*Revised Structure Type Study*

**Ramp B over Fairground Road**

**SCI-823-0.00**  
**PID No. 19415**

• ODOT Review Comments of Original Structure Type Study with Consultant Responses

**PLAN**

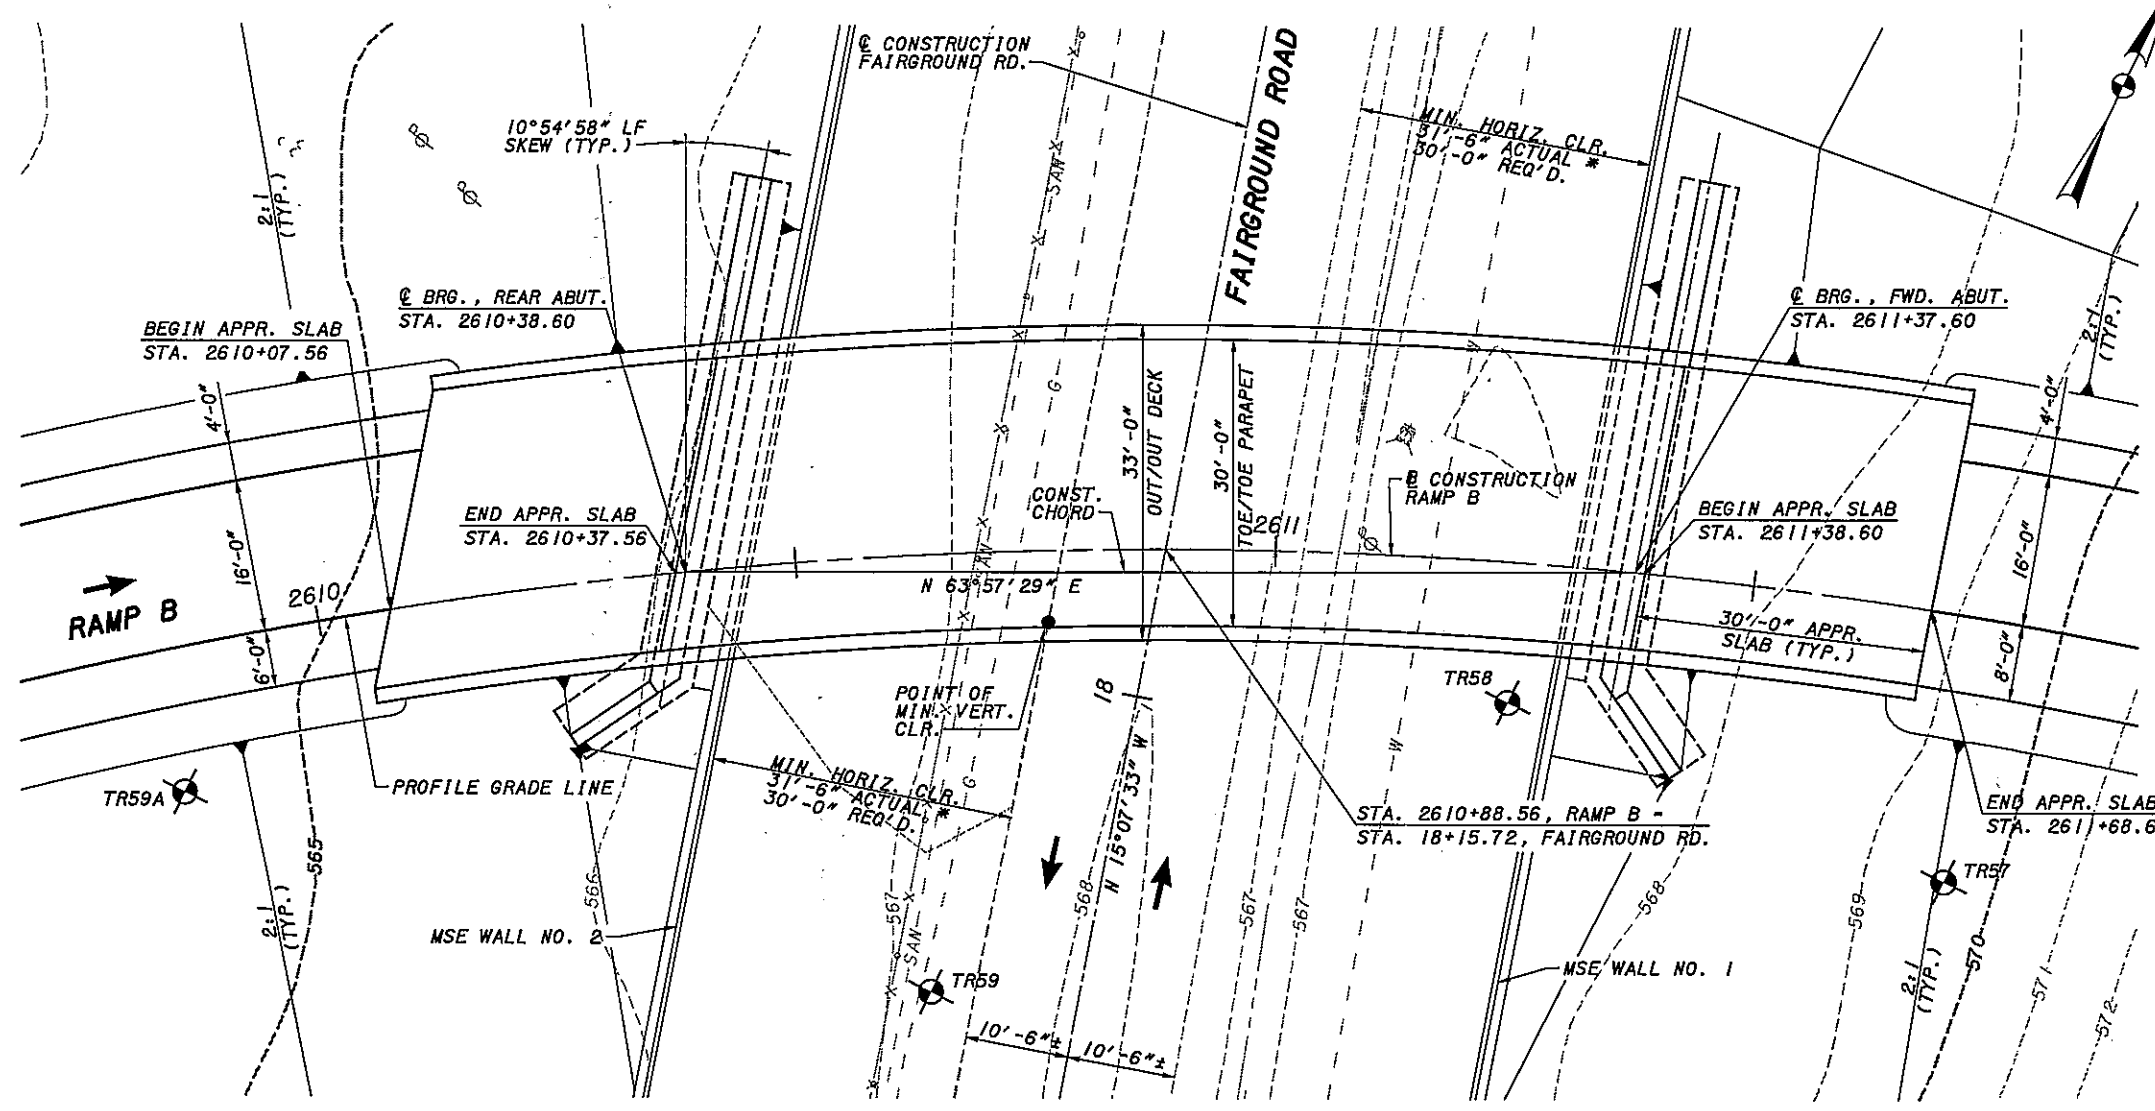
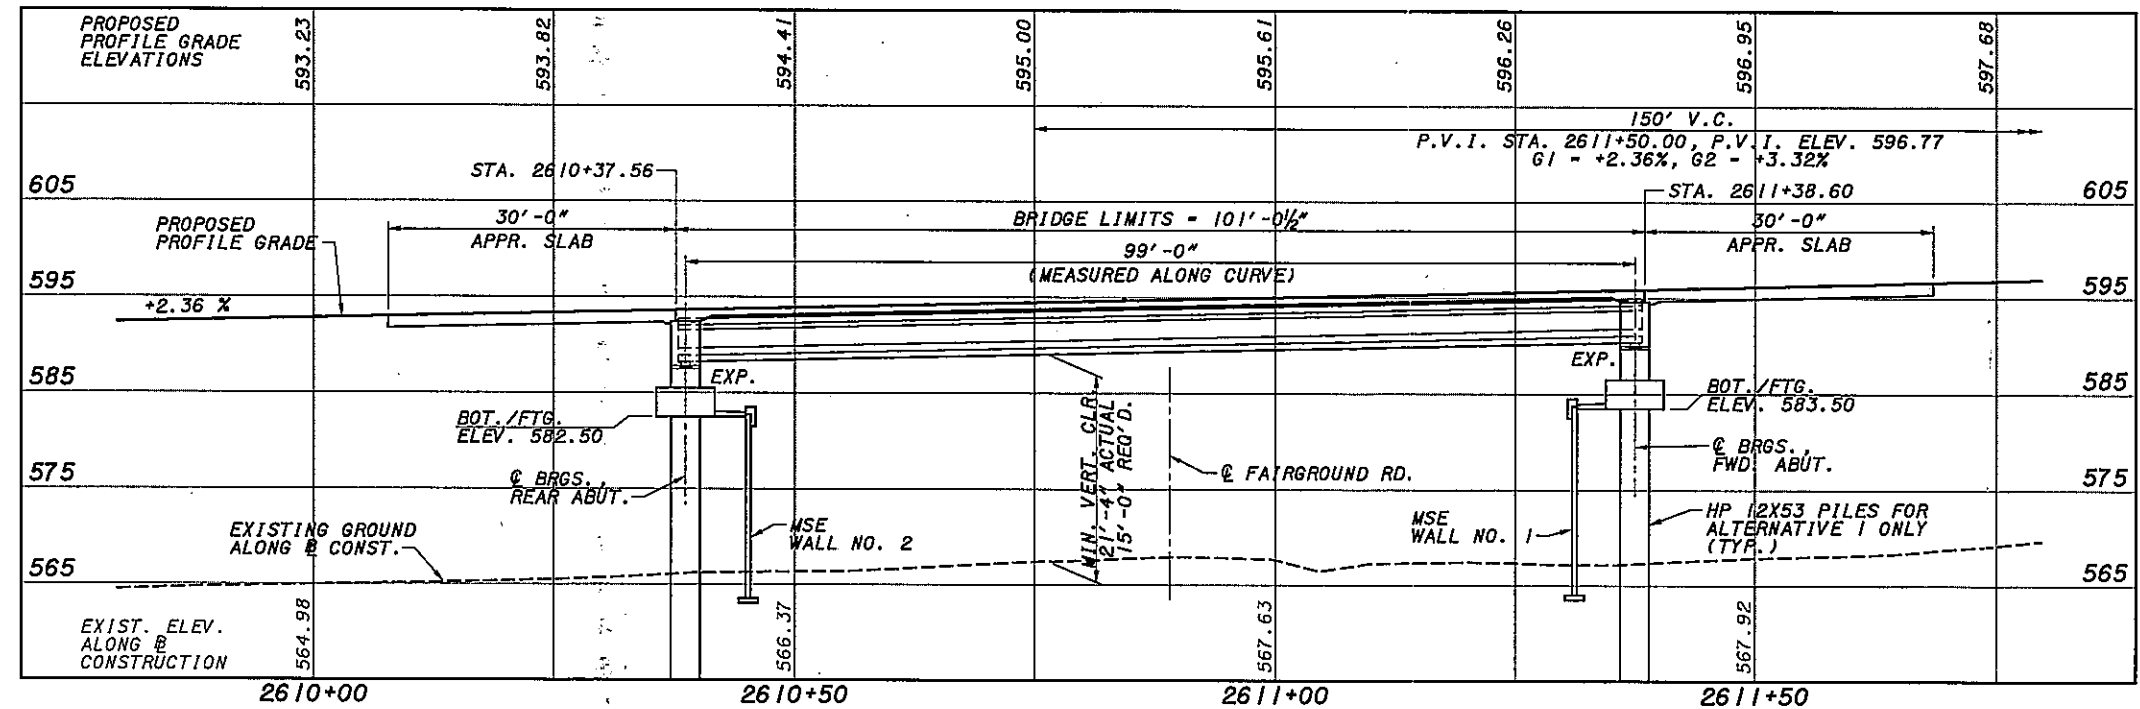
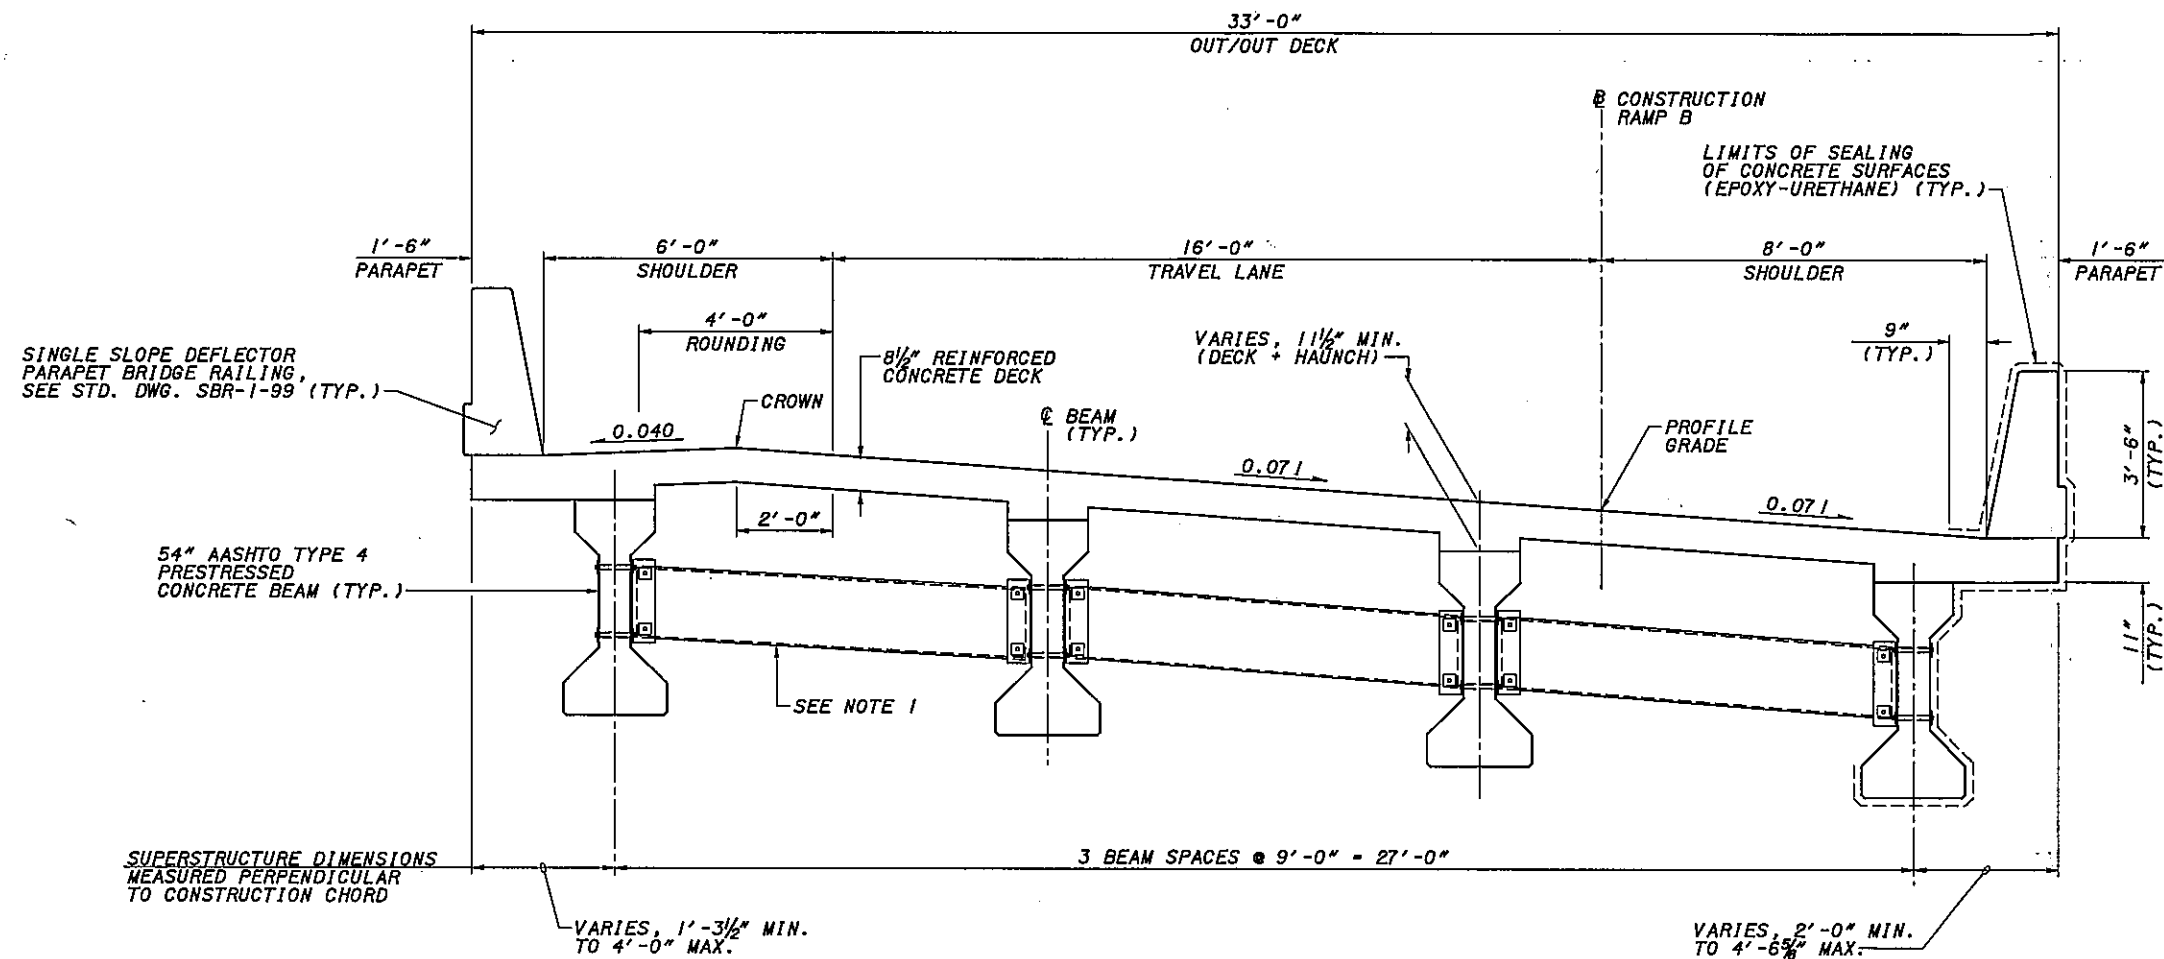
3. The profile grade for the entire project needs to be reevaluated in one more time in order to minimize the difference between the amounts of cut and fill. We feel that the 22'-2" proposed vertical clearance shown on the Site Plan can be further reduced. Please verify the minimum required vertical clearance for the proposed structure. Refer to L&D Manual, Volume 1, Fig. 302-1E.

4. We could not verify the 10'-0" minimum required horizontal clearance. Please refer to L&D Manual, Volume 1, Fig. 600-1.
5. The existing lane widths for Fairground Road are shown as 2-lanes @ 10'-6" per lane. Fairground Road might experience an increase in traffic at some point in time upon completion of this project. Is there a plan for future widening for Fairground Road or was this even

<p>Site Plan (1/3)</p>	<p>3. The profile grade for the entire project needs to be reevaluated one more time in order to minimize the difference between the amounts of cut and fill. We feel that the 22'-2" proposed vertical clearance shown on the Site Plan can be further reduced. Please verify the minimum required vertical clearance for the proposed structure. Refer to L&amp;D Manual, Volume 1, Fig. 302-1E.</p>	<p>Will comply. Per the L&amp;D Manual, the preferred vertical clearance for Fairgrounds Road is 15'-0". In this re-submittal package, we are proposing a structure with minimum vertical clearance of 21'-4". The profile grade is being driven by the Ramp B over Norfolk Southern bridge to the west, specifically with the addition of two new rail lines per District direction in March 2006. The re-submittal of the Ramp B over Norfolk Southern bridge will be provided at a later date.</p>
<p>Site Plan (1/3)</p>	<p>4. We could not verify the 10'-0" minimum required horizontal clearance. Please refer to L&amp;D Manual, Volume 1, Fig. 600-1.</p>	<p>Will comply. The minimum required for an MSE outside the clear zone is 30'-0"; the span has been adjusted to meet this minimum horizontal clearance.</p>

<p>Site Plan (1/3)</p>	<p>5. The existing lane widths for Fairgrounds Road are shown as 2-lanes @ 10'-6" per lane. Fairgrounds Road might experience an increase in traffic at some point in time upon completion of this project. Is there a plan for future widening for Fairground Road or was this even considered? This will affect the proposed bridge limit.</p>	<p>The District spoke to the Scioto County Engineer regarding this. Per communication dated September 1, 2005, there are no plans to widen Fairgrounds Road in the future, but allow for 24' pavement.</p>
<p>Site Plan (1/3)</p>	<p>6. Please check if the 45-degree wingwalls can be utilized at the Northwest and Northeast wingwalls similar to what are being shown at the Southwest and Southeast wingwalls.</p>	<p>Will comply. However, from an aesthetic viewpoint, having the Northwest and Northeast wingwalls of this bridge mate with the Southwest and Southeast wingwalls of the SR 823 over Fairgrounds Road bridge would be visually superior.</p>
